**Proposed Temporary Warehouse (excluding Dangerous Goods Godown)
and Open Storage of Construction Materials and Machinery for a Period of 3 Years in
“Comprehensive Development Area(1)” Zone, Lot 1095 RP (Part) in D.D. 107
and Adjoining Government Land, Kam Tin, Yuen Long, New Territories**

(S.16 Planning Application No. A/YL-KTN/1214)

Response-to-Comment (RtC)

SUBMISSION REPORT
FOR
DRAINAGE PROPOSAL DESIGN
FOR TEMPORARY WAREHOUSE (EXCLUDING DANGEROUS
GODOWN) AND OPEN STORAGE OF CONSTRUCTION MATERIALS
AND MACHINERY FOR A PERIOD OF 3 YEARS
ON
LOT 1905(PART) IN D.D.107
KAM TIN, YUEN LONG, N.T.

DRAWING TITLE:
DRAINAGE PROPOSAL PLAN AND TYPICAL DETAILS

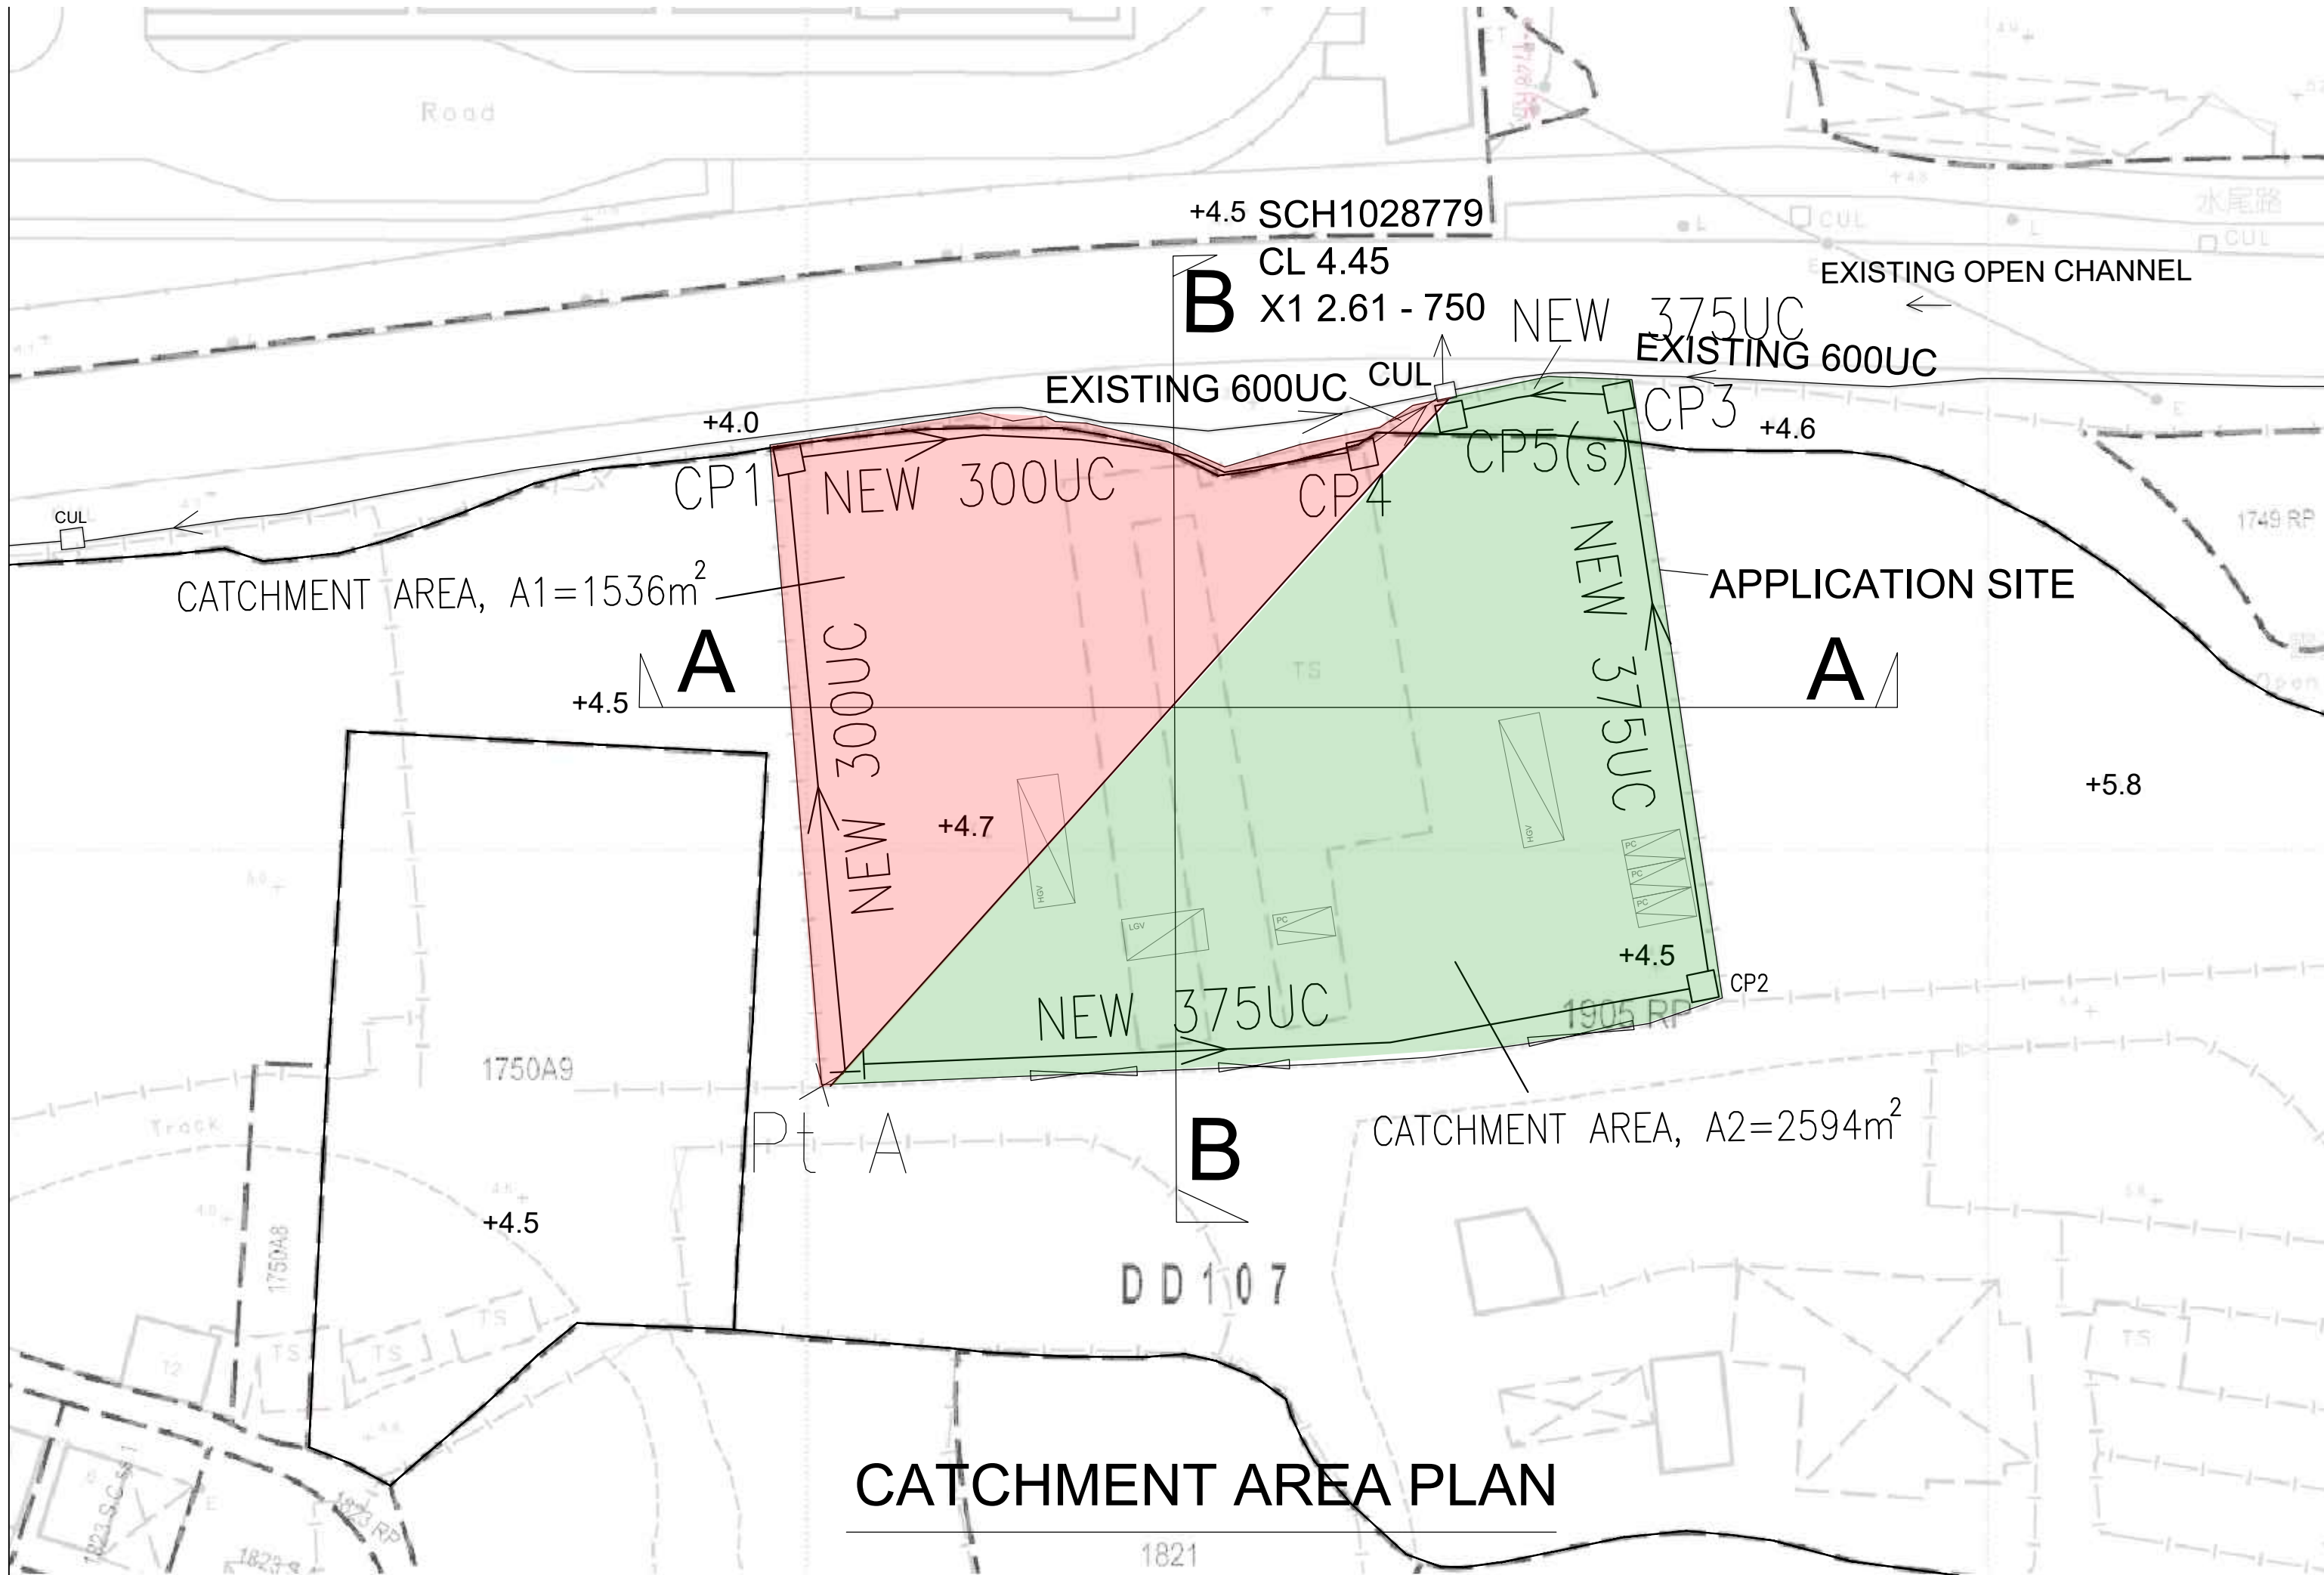
1. Comments of the Director of Environmental Protection (DEP)		
(a)	Grateful if you could ask the applicant to confirm whether the proposed use would involve storage of materials of dusty nature (e.g., cement, earth, pulverized fuel ash, aggregates, silt, stonefines, sand, debris, sawdust and wooden chips). If affirmative, whether those materials are packaged.	Section 1.2 of the supplementary statement has stated that the proposed warehouse is intended for the storage of miscellaneous goods such as packaged food, apparel, footwear, electronic goods, furniture etc.; whereas the open storage is intended for the storage of construction materials such as steel beam, bricks, scaffold etc. and machinery such as generator, elevated platform etc. The materials to be stored at the application site are not dusty in nature. No storage of dusty materials will be allowed at any time during the approval period of the planning permission.

(ii) The applicant provides a drainage proposal in support of the application. Please refer to **Annex 1**.

The proposed stormwater drainage works include surface U-channels at the peripheral of the site collecting the runoff from catchments within the site. The U-channels will connect and discharge the surface runoff to the existing government open channel. Catchpits with 300mm sump are proposed at the discharged points of proposed U-Channel to desilt the surface water before discharging to the drainage outside. The proposed stormwater drainage layout plan is shown in **Appendix A**.
